SUMMARY

This report concerns the amended plans and additional information submitted to Council on 30 January 2018 for an application to demolish the existing improvements and construct a mixed use development consisting of a 6 storey building (Building A) with roof terrace fronting McGill Street and a 8 storey building (Building B) fronting the light rail line containing a total of 88 dwellings and 1 commercial tenancy within Building A for use as art gallery and café space with 2 basement car parking levels and associated landscape works. The amended plans and additional information were submitted in response to the resolution of the Sydney Eastern City Planning Panel (SECPP) at its meeting on 7 December 2017.

1. Background

Image 1: Amended Ground Floor Plan

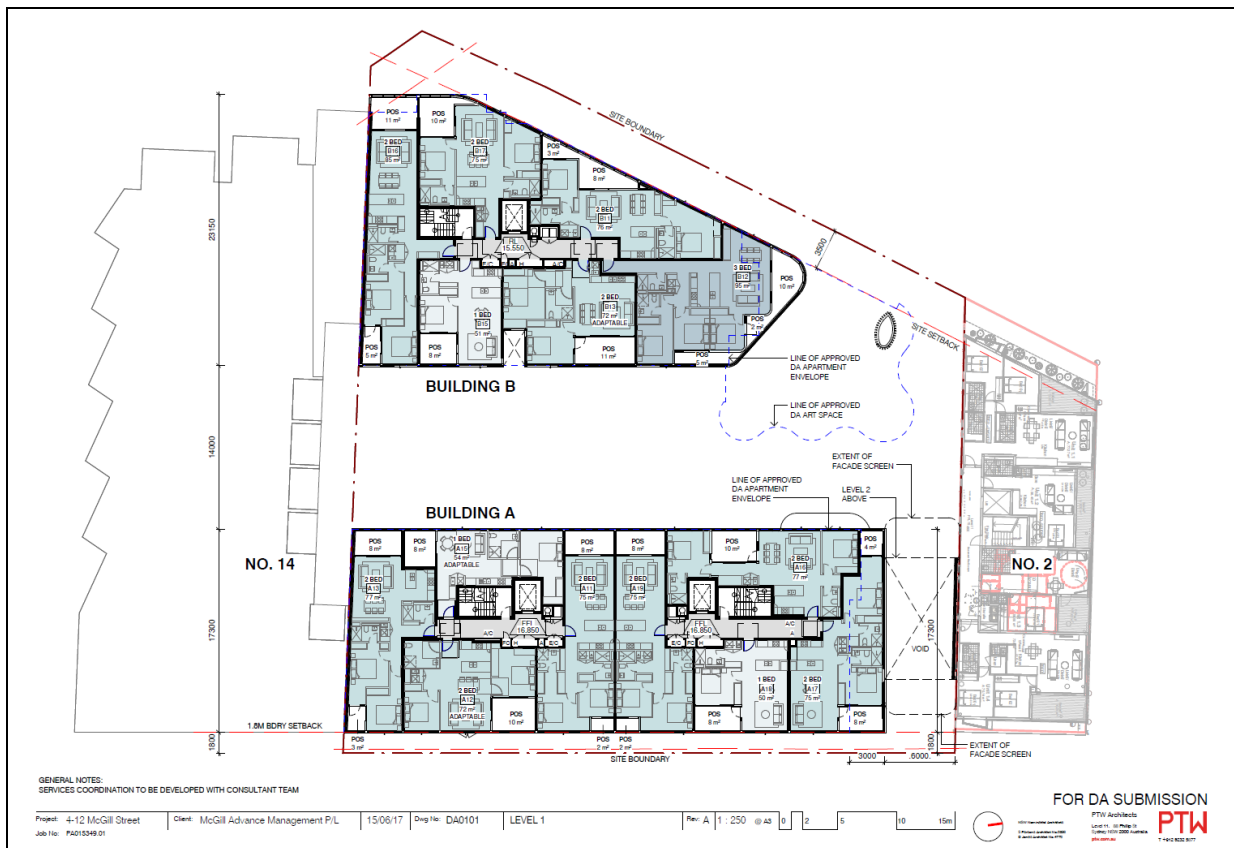
The amended plans detail a number of changes to the pedestrian through site link to facilitate an easement for physical access and light & air benefitting the future development of No. 2 McGill Street including:

- a. Re-grading of the through site link to provide ramped access from McGill Street up to a raised link at a height of RL 12.950 AHD, with stairs and a ramped access to a publicly accessible walkway at the rear of the site fronting the Greenway.

- b. Three dimensional plans indicating an easement for pedestrian access and light & air along a portion of the northern boundary of the site up to a level 29 metres above the ground floor level;

- d. An access point for the fire stair and services cupboard for the development at No. 2 McGill Street, albeit located 675mm above the floor level indicated on the indicative plans for No. 2 McGill Street; and

The preferred outcome would be for the through site link to follow the natural grade of the site sloping down from McGill Street towards the rear of the site, negating the need for a large level change at the western end of the site, whilst providing level access to the café/art space on the subject site as well as both commercial tenancies on No. 2 McGill Street.

It is not clear from the SECPP resolution whether the panel sought for access to be provided to both commercial tenancies of No. 2 McGill Street, however the plans only indicate physical access being achieved to Commercial Tenancy 2 with the opportunity for windows to be provided for Commercial Tenancy 1. The easement will also allow windows to be provided for the residential floors above, with the exception of the area covered by the 'bridge'.

Image 2: Amended First Floor Plan

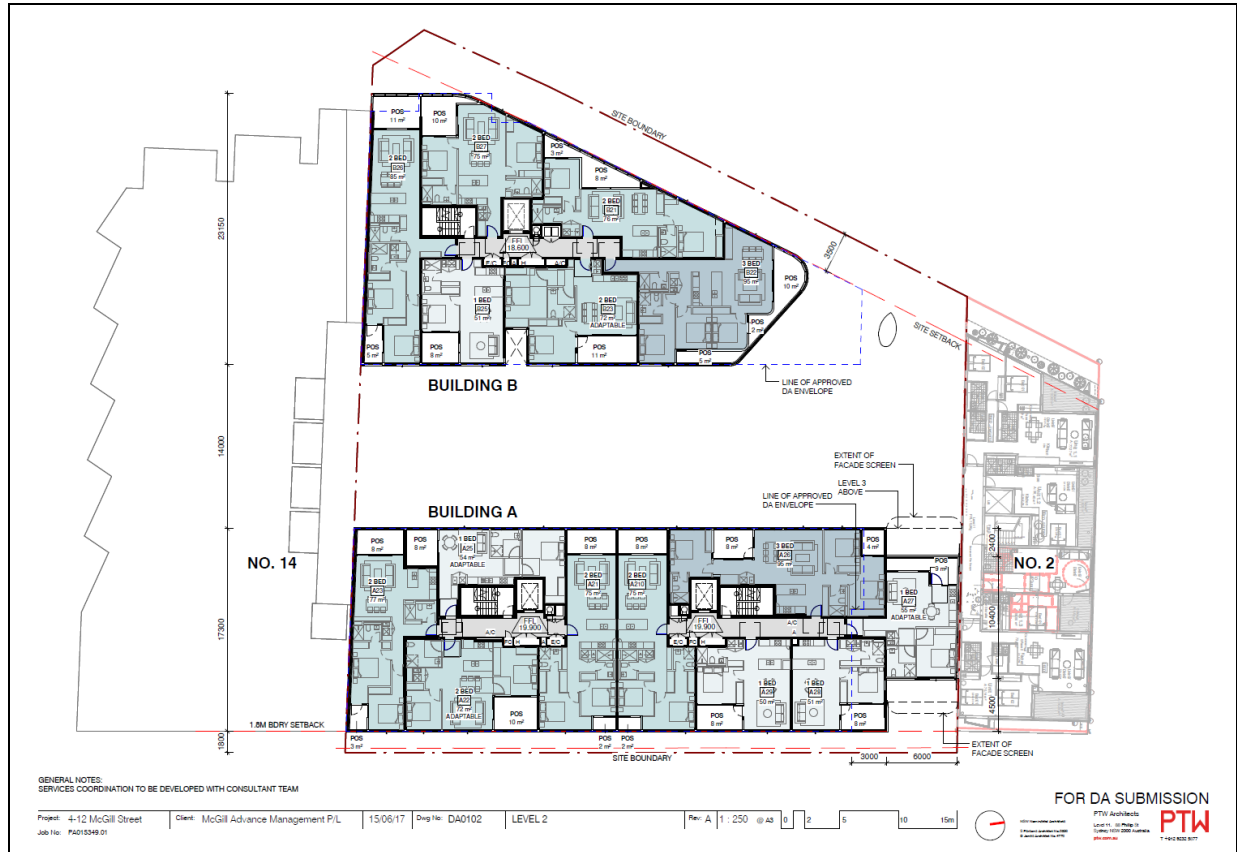
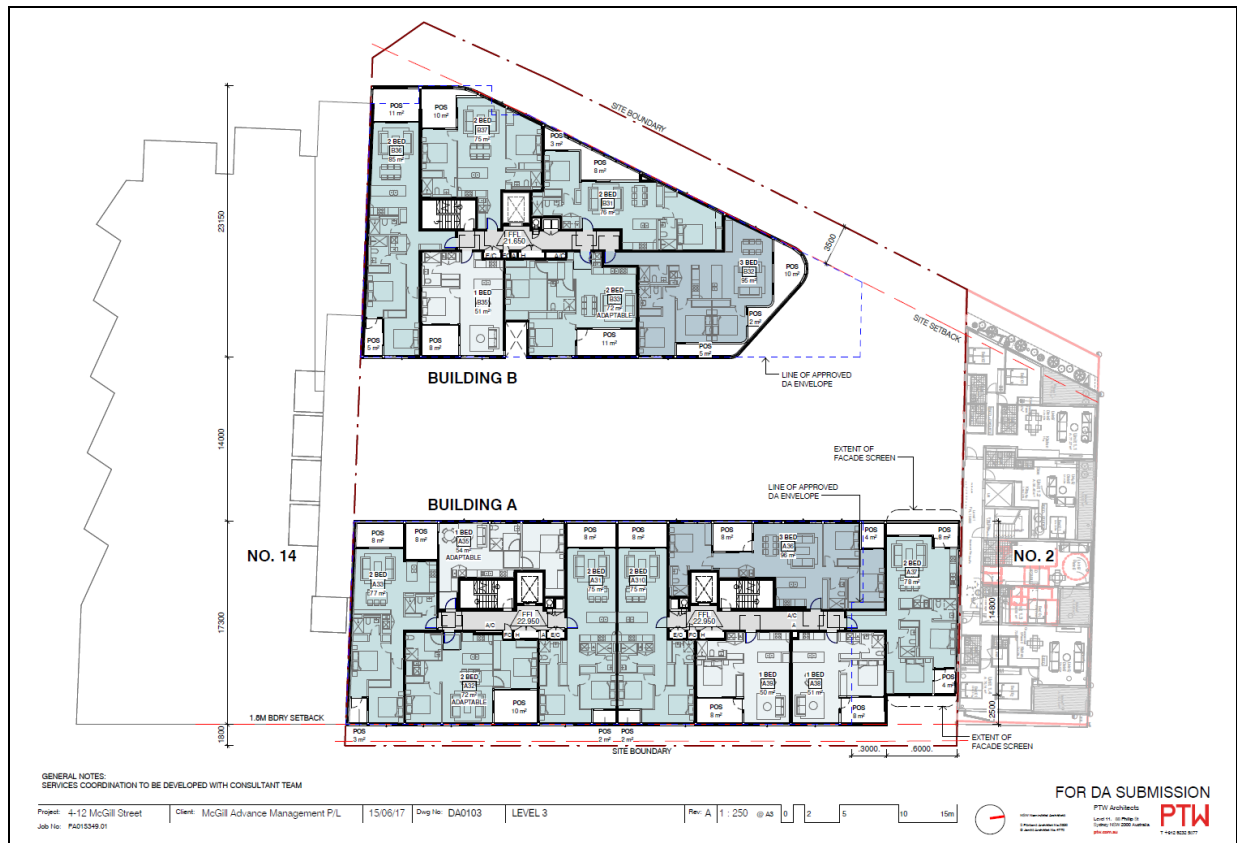
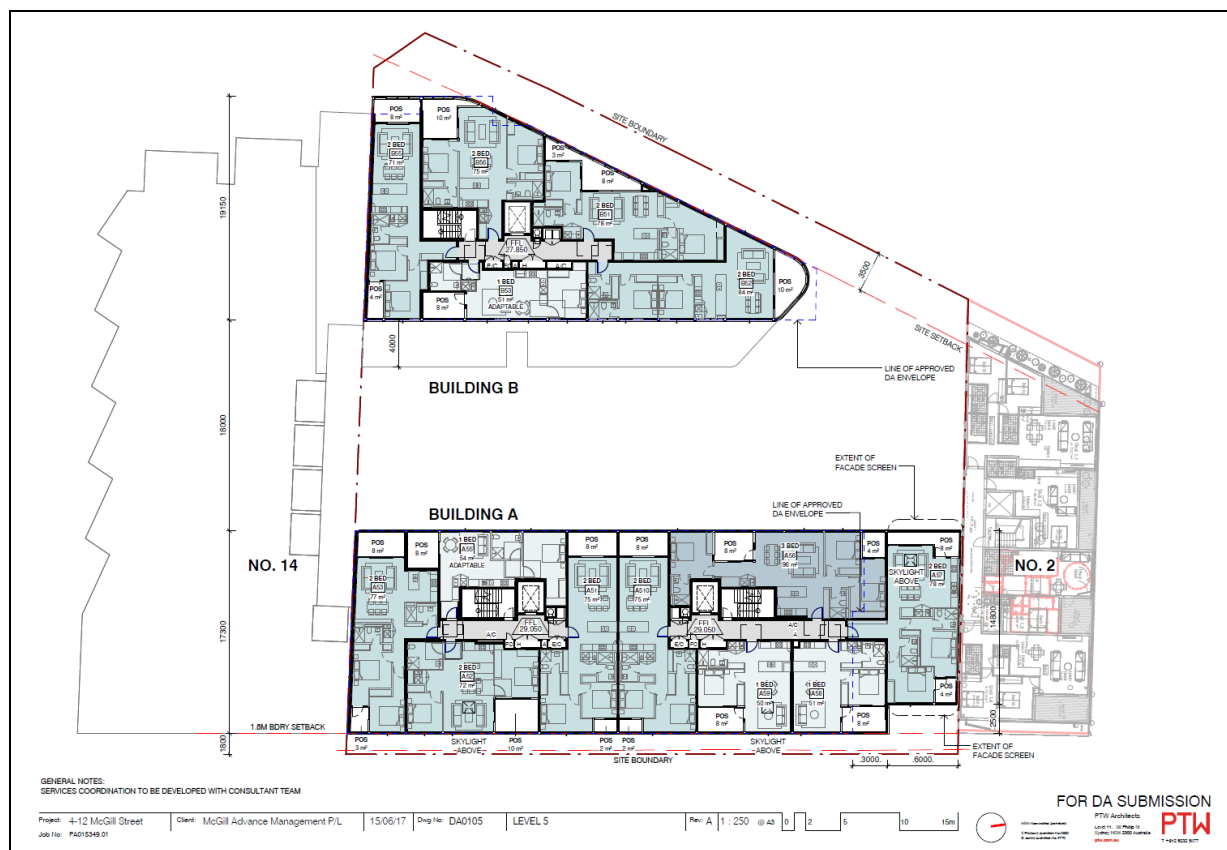
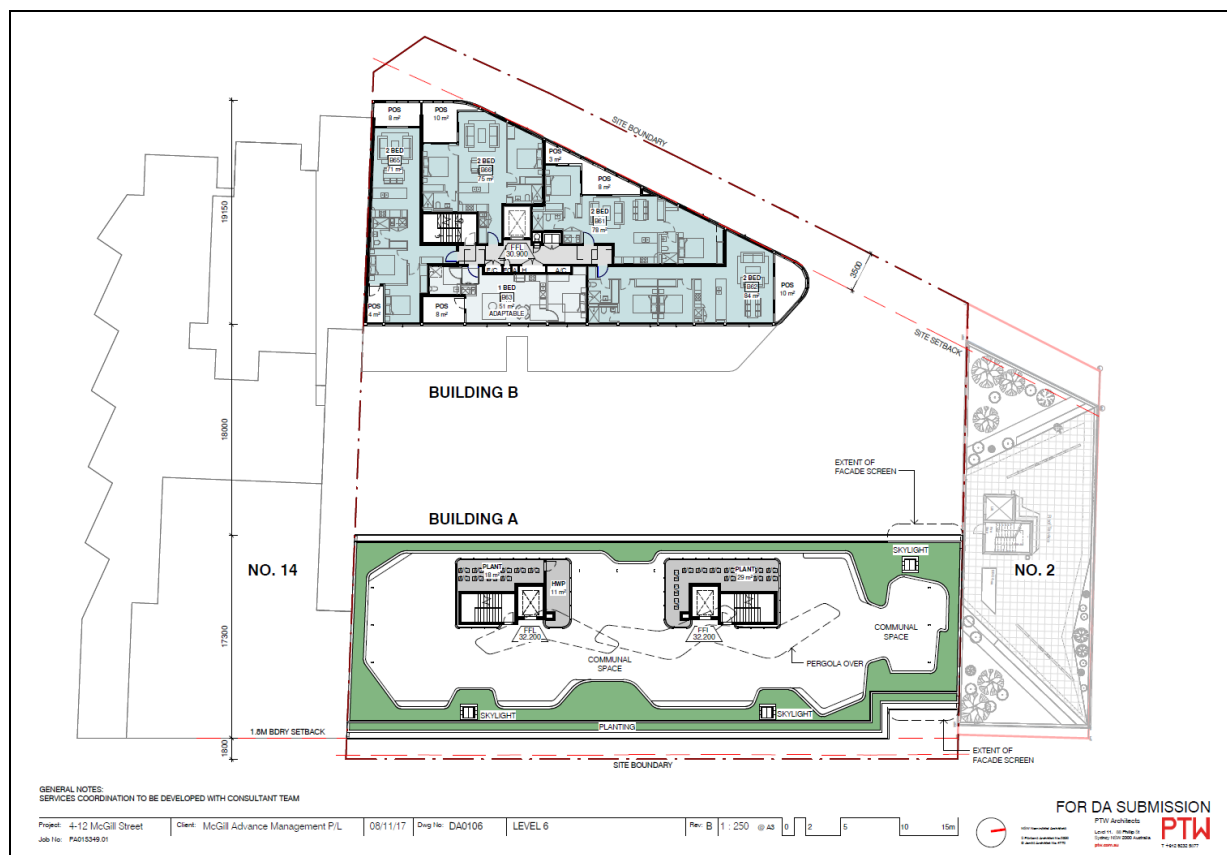
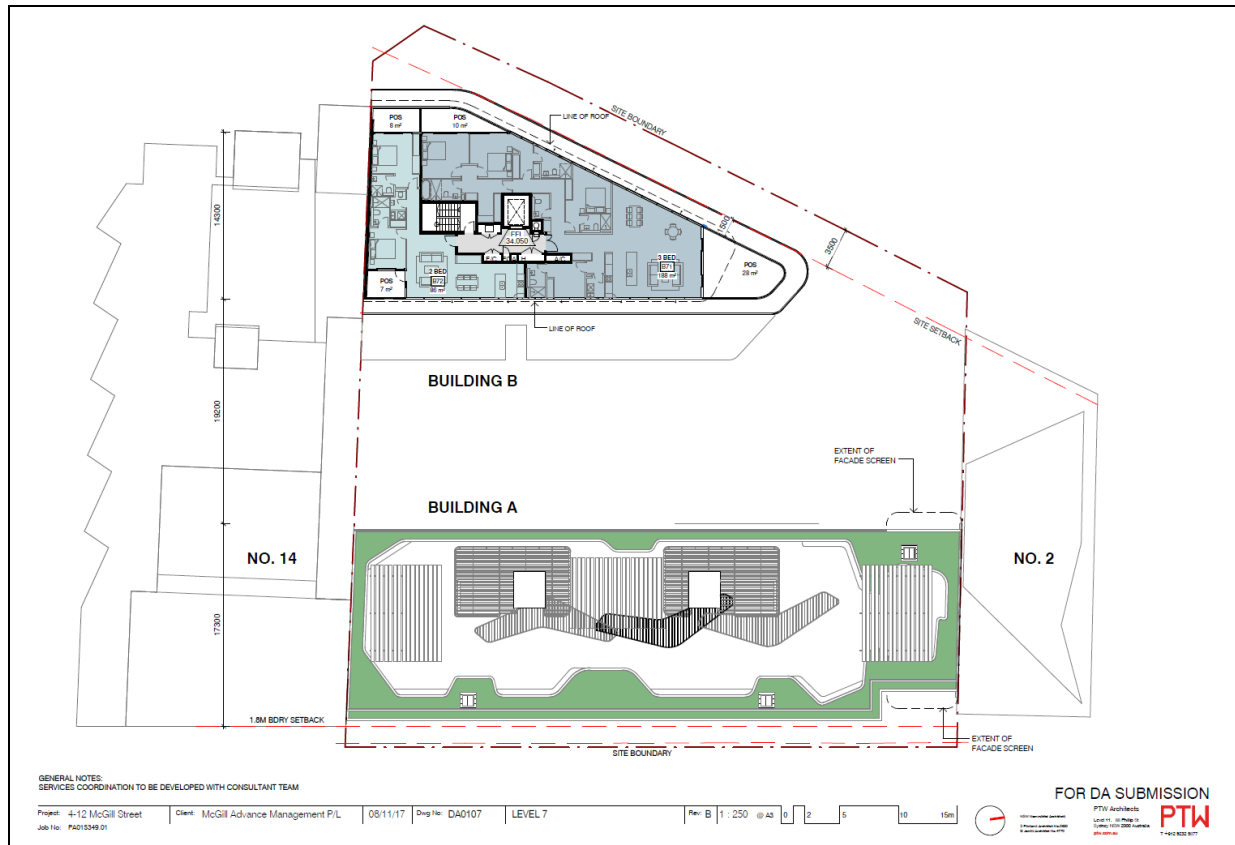
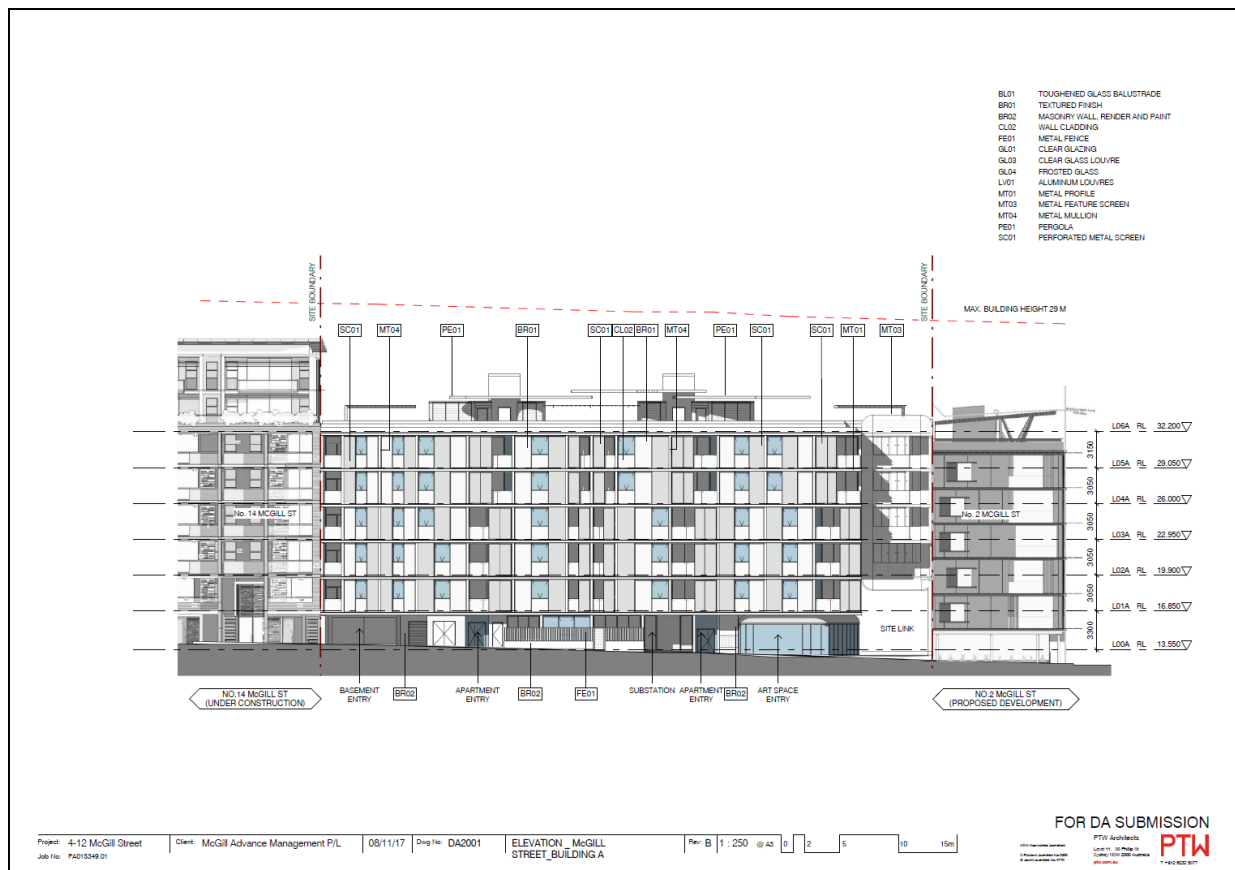
The amended plans submitted to Council make changes to those units provided with undersized primary balconies such that all balconies in the development now comply with the ADG minimum size requirements.

Notwithstanding, there are a number of units provided with balconies that do not meet the minimum depth requirements prescribed by the AGD, including the balconies servicing Units B11, B21, B31, B41, B51, B61, A27, A37, A47 and A57. It has not been demonstrated that these balconies can provide outdoor dining tables and thus provide a reasonable level of amenity for future occupants.

It is therefore considered that the amended plans do not satisfy the resolution of the SECPP.
